17_147

68-72 GREAT SOUTH ROAD, POKENO – TRANSPORT PEER REVIEW

Gull New Zealand Limited (the Applicant) propose to develop a 24-hour service station at 68-72 Great South Road, Pokeno. Waikato District Council require a review of the Applicant's transportation assessment report and potential effects, related to transport, of the proposal.

Figure 4: Proposed layout of Pokeno Road/Great South Road Signalised Intersection (From Graham Block, Pokeno, Integrated Transport Assessment, Arrive 2017).

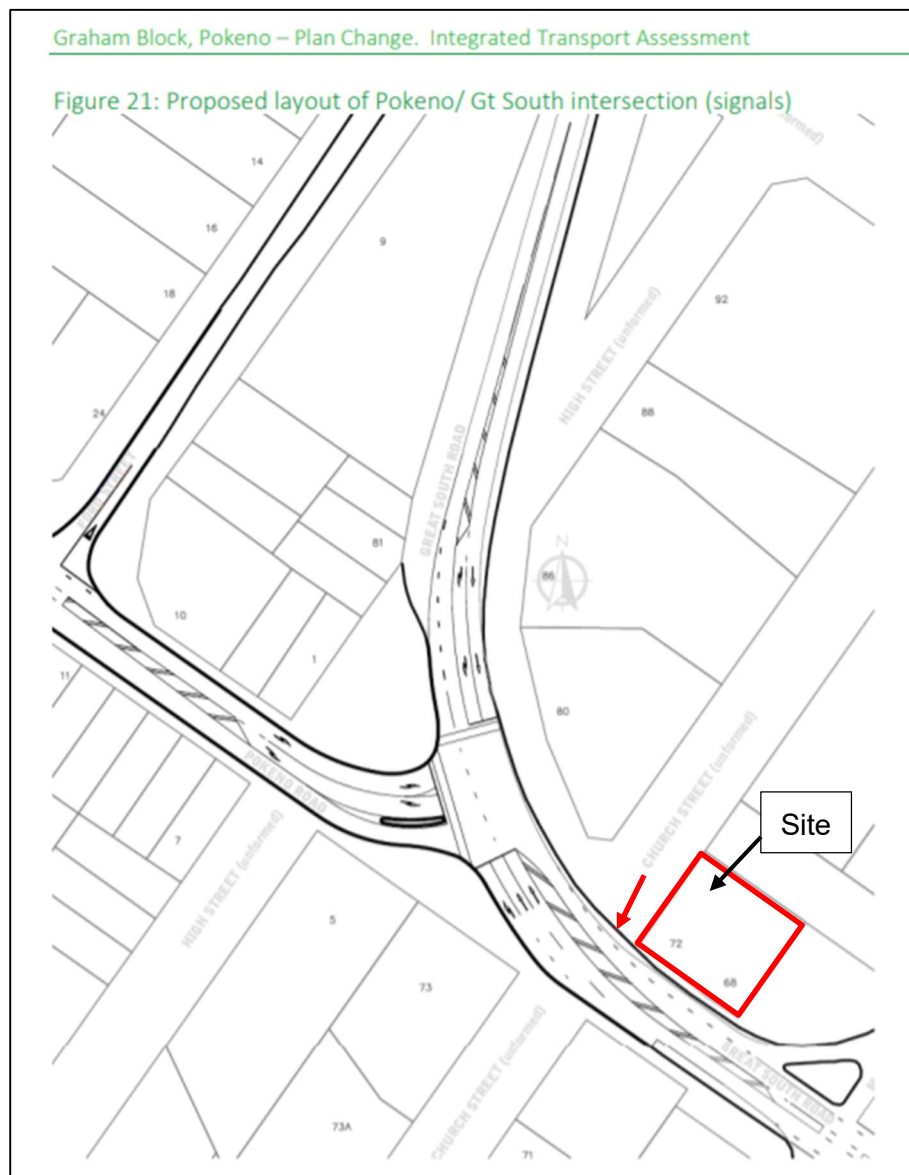
We note that the figure shows road widening where Great South Road intersects with the unformed section of Church Street (indicated by the red arrow). The potential loss of berm space may result in adverse safety effects for the proposed development at 72 Great South Road.

The proposed road layout does not appear to allow for future provision of pedestrian or cycling paths on Great South Road.

Figure 7: Proposed Vehicle Crossing Dimensions (Drawing 2998-B03, Rev F)

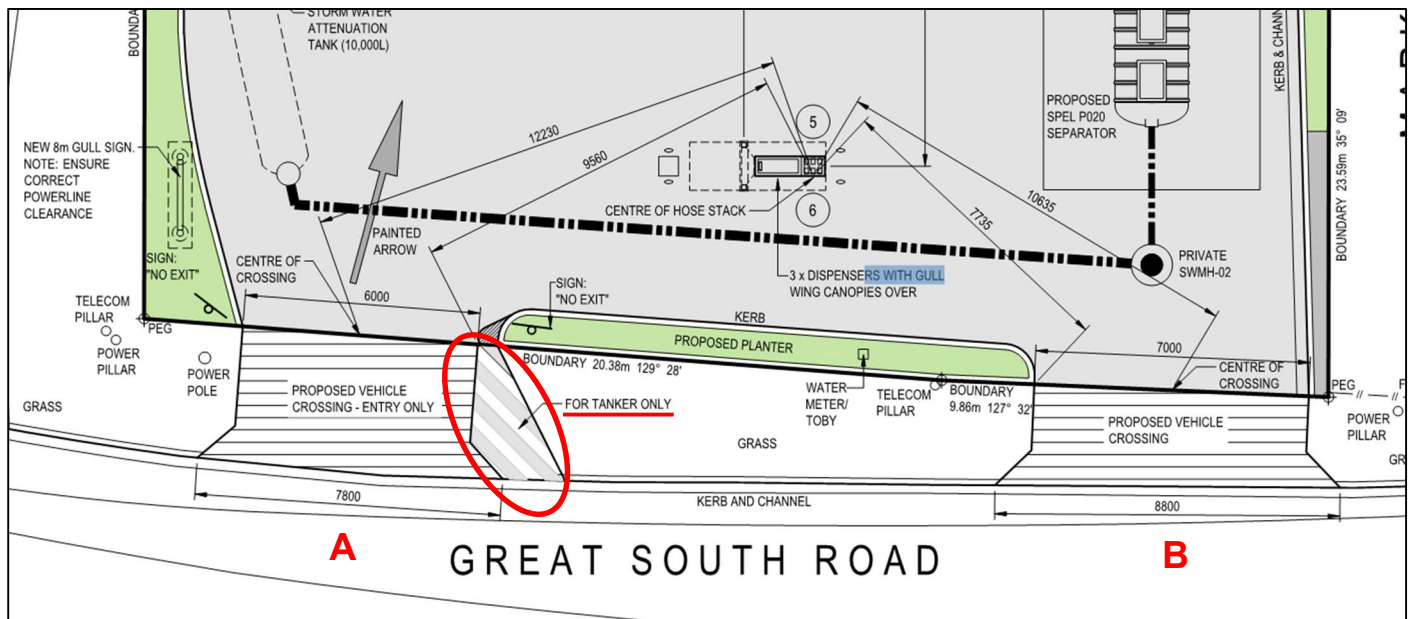
The ODP allows for a maximum crossing width of 6.0m at the boundary and 7.0m at the kerb. Crossing A is 6.0m wide at the boundary and 7.8m wide at the kerb. If the additional widening (to accommodate the swept path of the fuel delivery tanker) is included, the crossing is 6.5m at the boundary and 9.4m at the kerb. Crossing B is 7.0m wide at boundary and 8.8m wide at kerb.

As shown below in Section 4.3.3 there is limited sight distance for vehicles exiting crossing A. The proposal includes signs and markings to reinforce crossing A as “Entry Only”. However, we are concerned that the wide crossing may encourage vehicles to exit at crossing A, because it appears wide enough for two-way use, and vehicles may enter the site at higher than appropriate speeds—increasing the risk of vehicle-vehicle conflict at the crossings.

Figure 9: Possible Vehicle Crossing Configuration, Showing Delineation of Proposed Crossings (Drawing 2998-B03, Rev F)

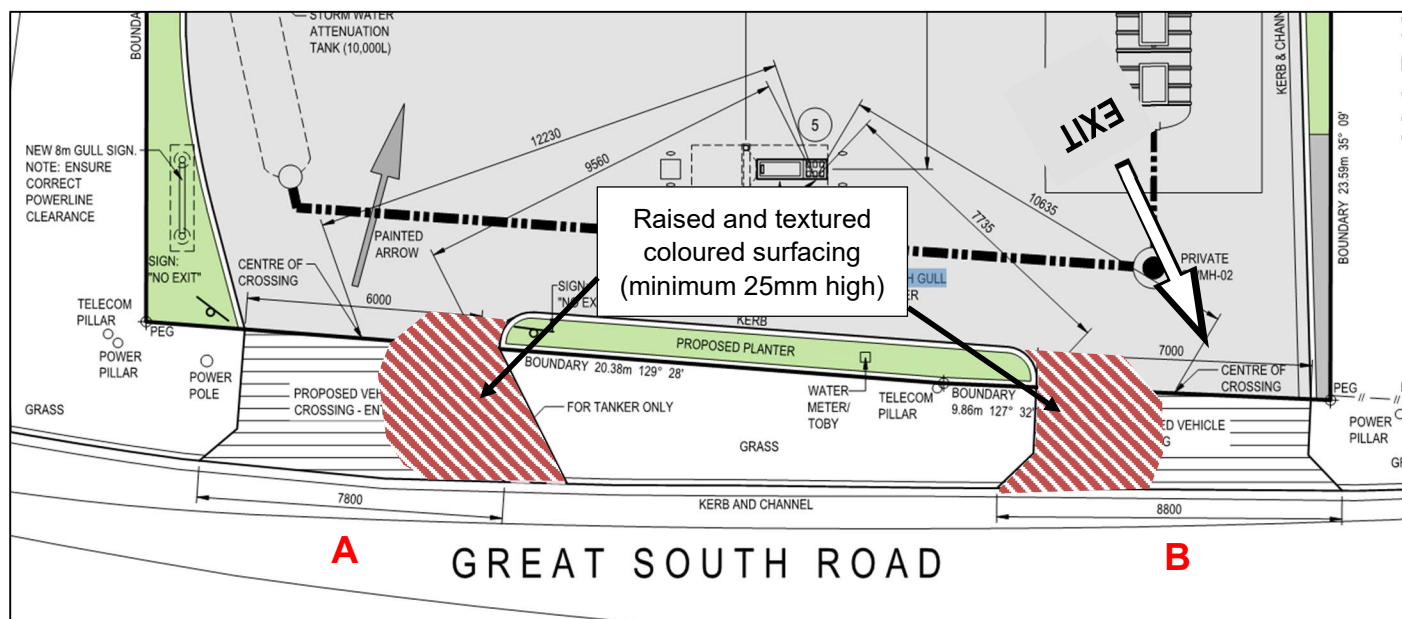
We consider it likely that the site will operate with predominantly one-way traffic flow – entry at Crossing A and exit at Crossing B. We suggest that Crossing B be signed and marked as “Exit Only” and treated with raised and textured coloured surfacing (minimum 25mm high) as recommended for Crossing A. This will improve flow on site and minimise the likelihood of vehicle-vehicle conflict.

Due to the short distance between the proposed vehicle crossing and the first fuel pump, we consider it necessary for the delineation treatment to extend to the road edge. If pedestrian or cycling paths are to be provided in the future, the vehicle crossing treatments may need to be revised (i.e. surfacing removed where the footpath is created).

- = Provide delineation of vehicle paths at crossing A and crossing B using raised and textured coloured surfacing (minimum 25mm high) subject to approval by Waikato District Council;

Figure 10: Separation Distances to Existing Vehicle Crossings (marked yellow) and Intersections

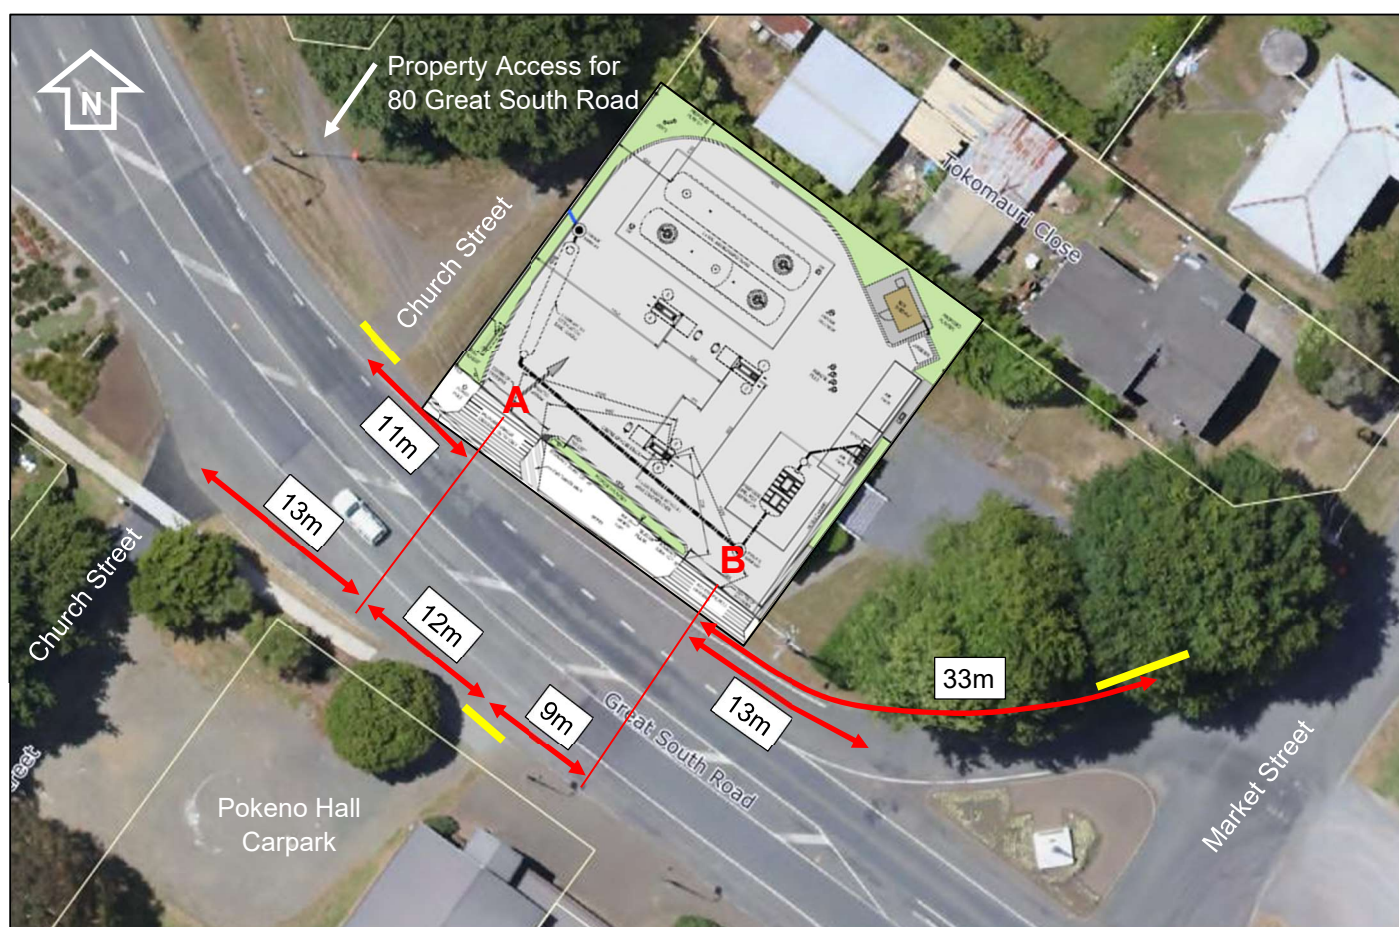
Table 9.B⁵ of the ODP specifies the minimum distance between crossings as 15m and requires 20m on the approach to a side road, or 30m on the departure from a side road. Table 14.12.5 of the PDP sets out the separation distances based on road hierarchy, being 15m between crossings and 30m to a side road for a collector or local road.

The proposed vehicle crossing locations do not satisfy the separation distance requirements of the District Plans. The separation distance to Pokeno Road and Market Street are satisfactory. However, we note that

proposed vehicle Crossing B is positioned within the diverge taper for the left turn slip lane into Market Street (north), with only 13m separation.

Figure 11: Possible Slip Lane Closure Option for Future Pokeno Streetscape Upgrade/Market Square Development

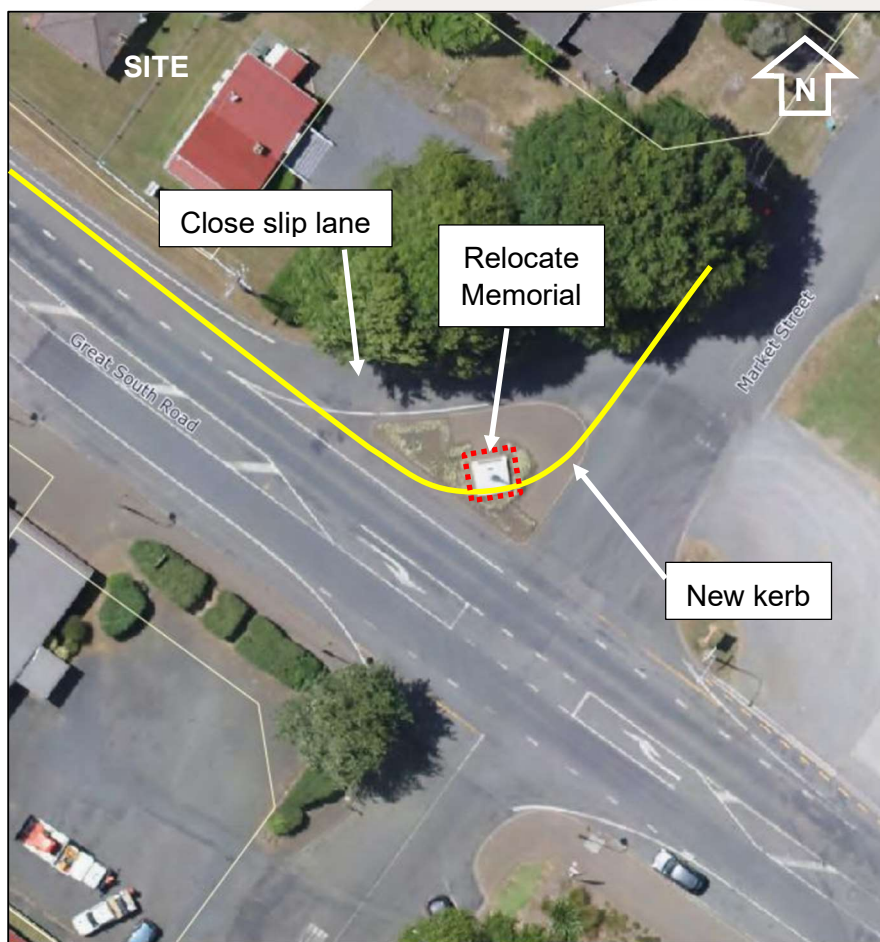
The slip lane provide access for vehicles turning left from Great South Road into Market Street, avoiding the First World War memorial located adjacent to the carriageway (on the splitter island). From a road safety perspective, the location of the memorial is inappropriate. People visiting the memorial must cross the road to access it and will be very close to traffic on Great South Road when reading the names and information displayed on the memorial.

It does not appear necessary to have a left turn slip lane in this location. If the memorial was relocated the slip lane could be closed and the kerb realigned to provide a standardised cross-roads intersection, consistent with the scale and form of other intersections in the town centre. This would simplify the intersection form, reducing the number of conflict points, improve pedestrian safety and enhance the public space.

We suggest that Council considers relocating the memorial and simplifying the Market Street intersection as part of any town centre streetscape works, irrespective of the proposed development at 72 Great South Road.

Figure 18: Sight Distance Requirements for the Proposed Vehicle Crossings

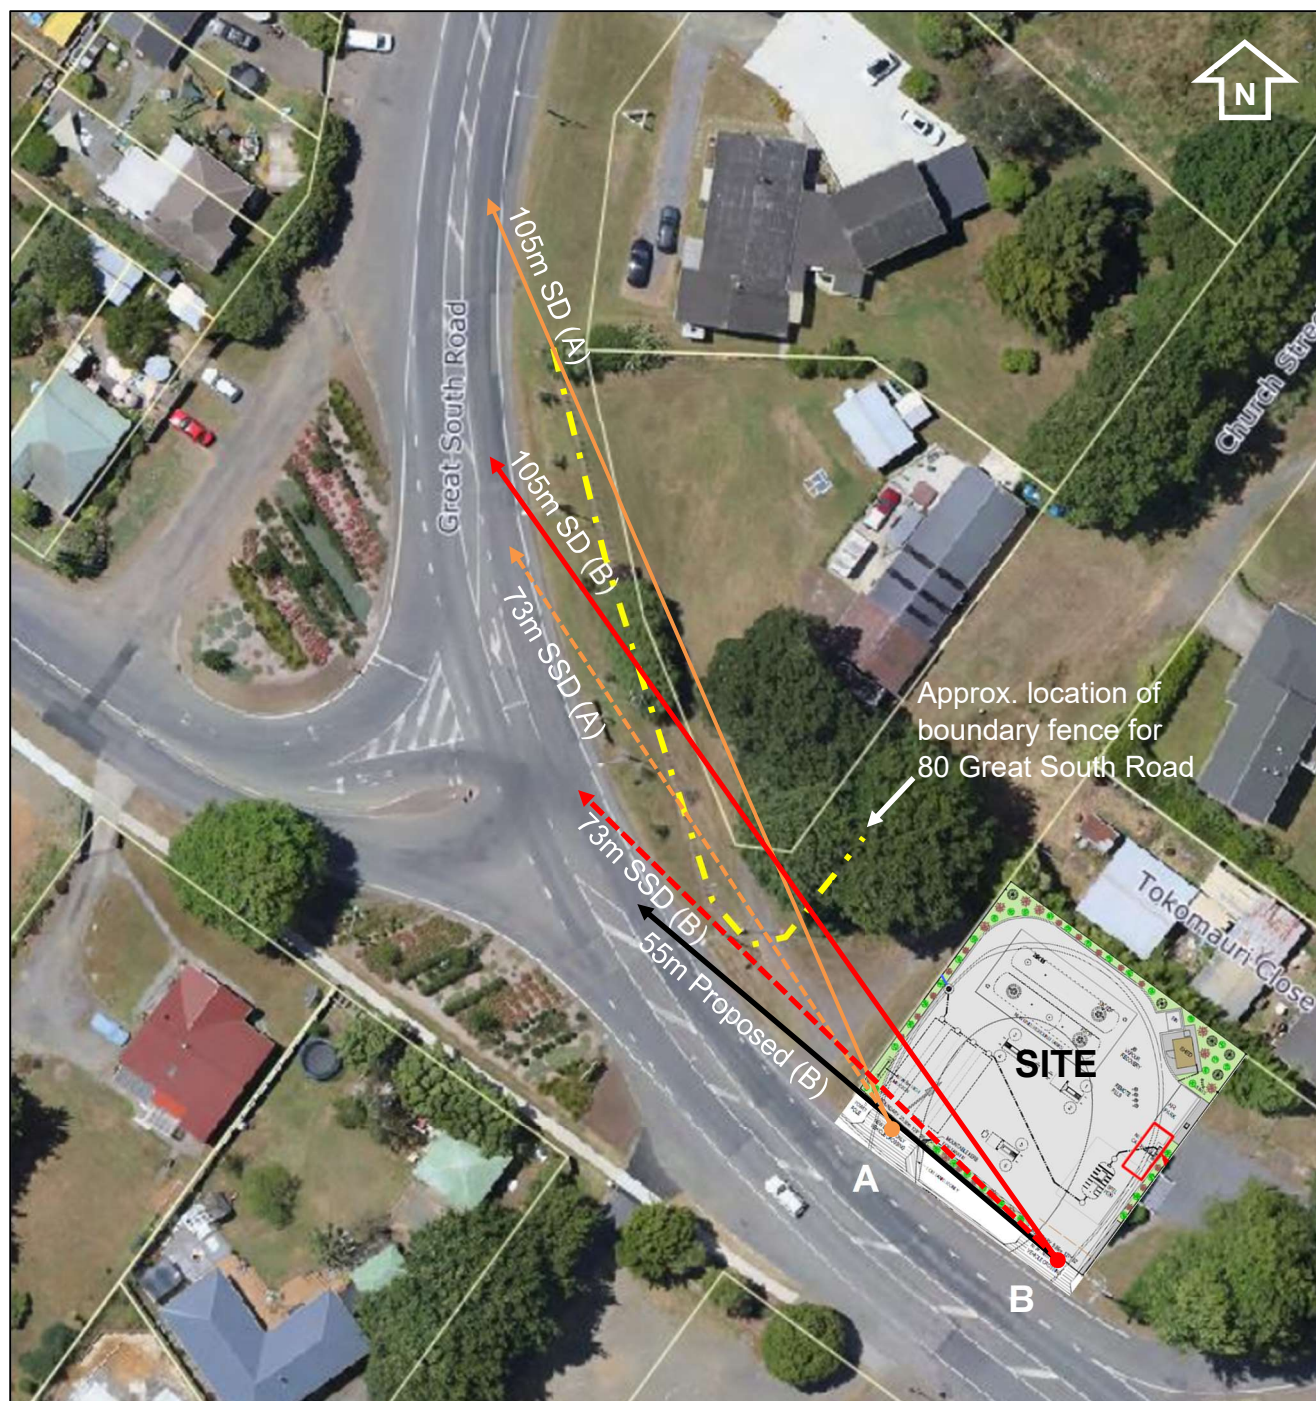
The PDP Table 14.12.5.3 requires 105m sight distance for a vehicle crossing generating more than 40 vehicle movements per day in an urban area with a speed environment of 60km/h. Where the operating speed is 50km/h the sight stance requirement reduces to 80m.

RTS 6⁶ requires 115m sight distance for high volume vehicle crossings (more than 200 vehicle manoeuvres per day) on a collector road with a 60km/h operating speed. Where the operating speed is 50km/h, the sight distance requirement reduces to 90m.

Sight distance to the south (looking left) from both proposed vehicle crossings is in excess of 150m and complies with the requirements of the ODP. Neither of the proposed crossings has sufficient sight distance to the north (looking right). The available and required sight distances are shown in the figure below.

Figure 20: Landscaping Plan and Plant Schedule, Showing Sight Lines from Figure 18 (Drawing 2998-B01, Rev A)

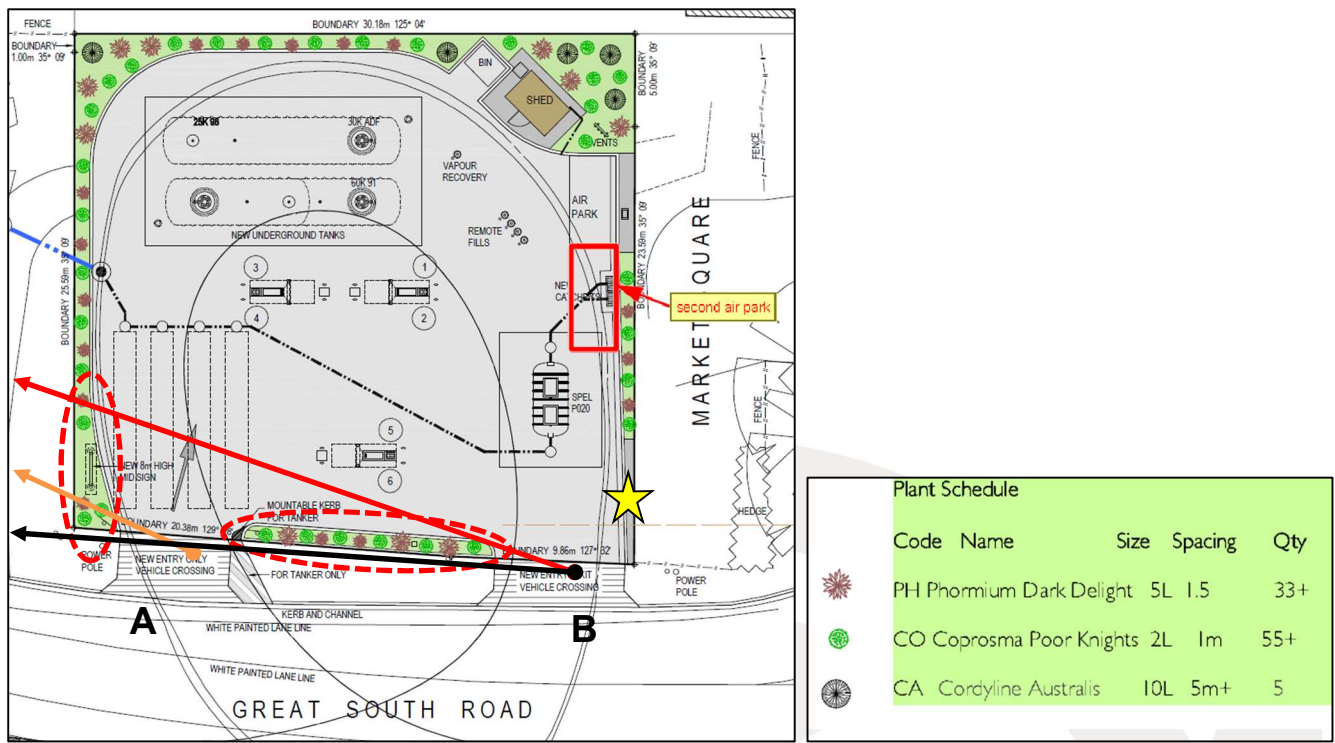
The supplied plans indicate the site will have screening planting along the Great South Road frontage and the western boundary with the unformed section of Church Street. These plantings could grow in excess of 1m high and obstruct sight distance from the vehicle crossings, reducing the available sight distance to about 55m (refer Figure 18). If there was no screen planting within the site, the shortfall in sight distance would be unchanged as the roadside vegetation and fence at 80 Great South Road would still block the sightlines. (As mentioned above the sightline within the road reserve is about 10m short of that required by the District Plan for an operating speed of 60km/h)

We recommend no screening planting is used in the areas circled red in the figure below and that any planting in these areas is maintained to a low height or limited to ground cover plants only. The planting within the site will need to be maintained to ensure sight distance for crossing B is not obstructed.

Figure 21: Proposed Sign (Drawing 2998-09, Rev B)

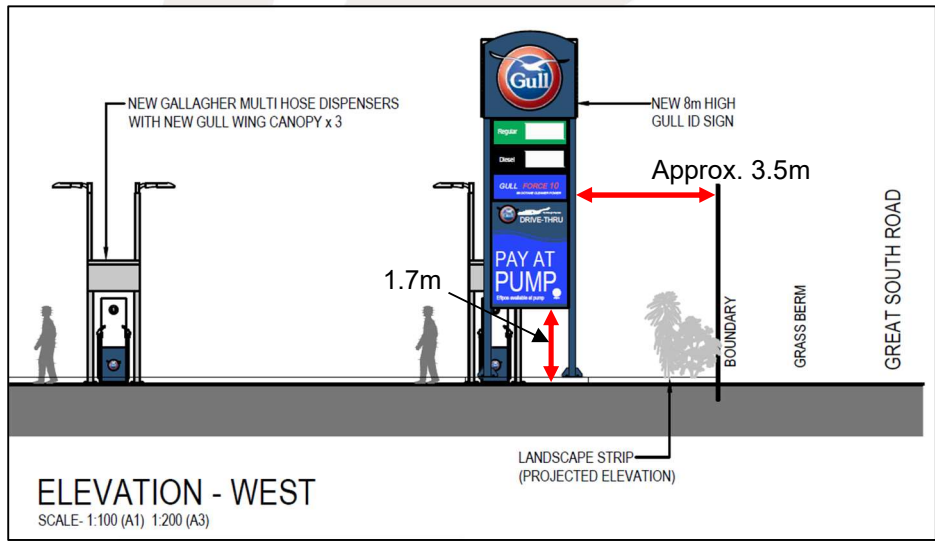
The proposed Gull ID sign is located near crossing A, approximately 3.5m from the boundary with Great South Road. The location of the sign obstructs sight distance for drivers exiting crossing B. We recommend the sign be relocated to the southern boundary (as indicated by the yellow star in Figure 20 above) to ensure sight distance for crossing B is maximised and unobstructed.

Figure 22: Queuing Diagrams (from TIA Figure 7 and 8)

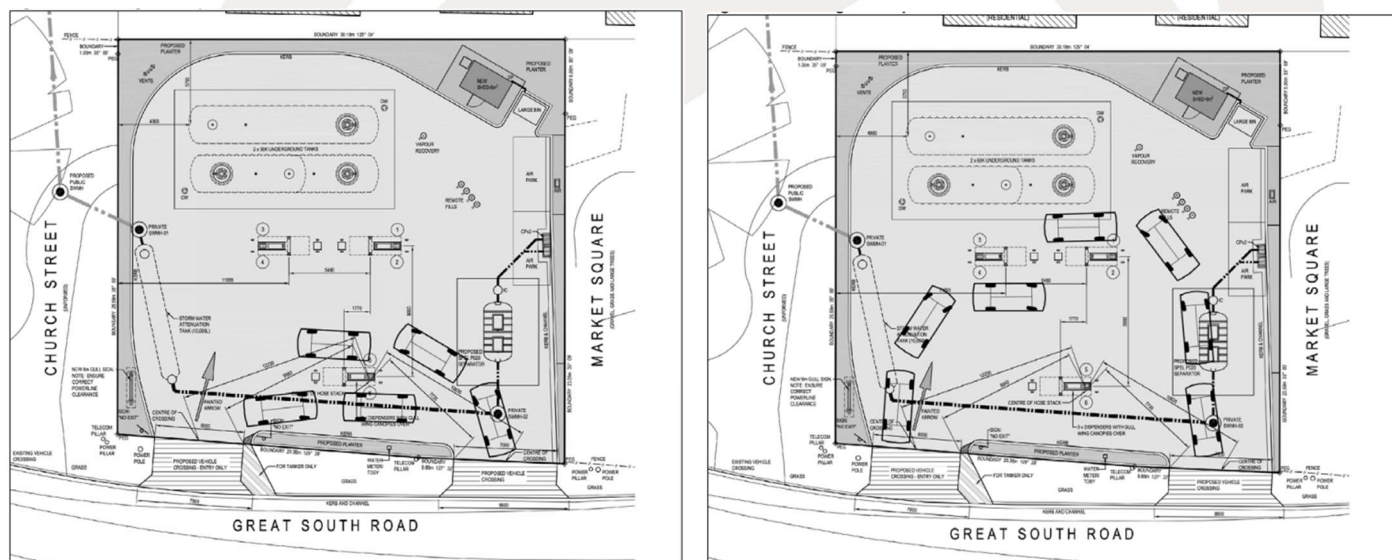
The TIA indicated there is enough queuing space on site for about 11 light vehicles. However, we note that the queuing vehicles may obstruct the vehicle crossings, making it difficult for a vehicle to exit when other vehicles are queuing, particularly when the fuel delivery tanker is on site. Congestion on-site may increase the likelihood of vehicles exiting via Crossing A.

The trip generation estimation indicates the six pumps will be required to serve up to 60 tph. This equates to approximately five vehicles per pump and an average visit duration of 12 minutes per vehicle if no queuing is to occur. This appears to be a reasonable rate of turnover for a service station and given the capacity for some on-site queuing.
